Transmission Competitive Solicitation Questions Log
Question / Answer Matrix
2021/2022 TPP – Phase 3

<p>the Stage 1 and the ultimate plan.</p> <p align="center">230 kV AC Switchyard at Newark Converter Station</p> 	
--	--	--	--

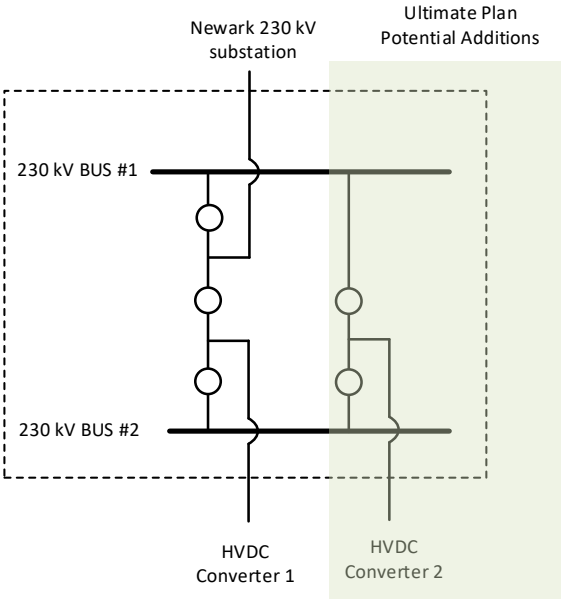
48	<p>Can you clarify the response to question 20 regarding the connection between Newark Converter Station terminal and the 230 kV yard? Specifically, does CAISO require a three breaker, single-bay breaker-and-a-half substation for the connection between the converter station and Newark Substation?</p>	<p>The following diagrams indicate the intended configurations for the 230 kV AC switchyards at Newark and NRS converter stations in</p>	Planning
